Access Compliance Report

Public Rights-of-Way

(Pedestrian Signals)

Intersection ID: N/A	Main Street:	Cross Street: N/A	Location: N/A
ADA ID: 361C0A8ABAD8	Signal Type: One Push Button-APS	Overall Compliance: No	Severity Score: BTN 1: N/A BTN 2: N/A No BTN: N/A
Codes/Mitigation Info/Possible Solution		Field Measurements/Component Compliance

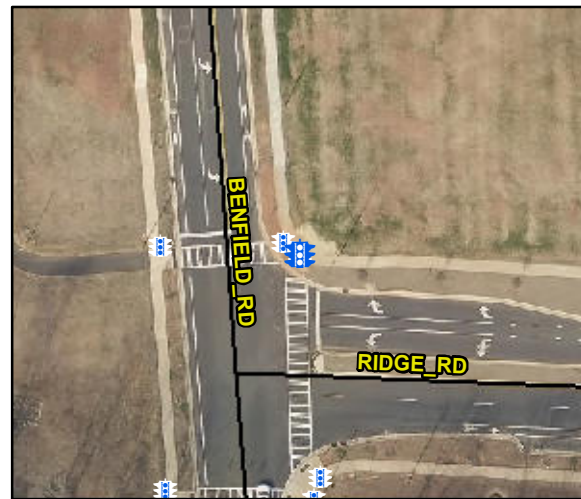
Possible Solutions: Replace Signal Push Button With APS Button on New Post. Remove & Relocate Sign.

N/A	B 1 Clear Xing Direction?	Yes	N/A	B 2 Clear Xing Direction?	N/A
	B 1 Crossing Direction	To S		B 2 Crossing Direction	N/A
Yes	B 1 DistanceTo XWalk (in)	0.0	N/A	B 2 DistanceTo XWalk (in)	N/A
No	B 1 DistanceTo Curb (in)	75.0	N/A	B 2 DistanceTo Curb (in)	N/A
Yes	B 1 Diameter (in)	2.0	N/A	B 2 Diameter (in)	N/A
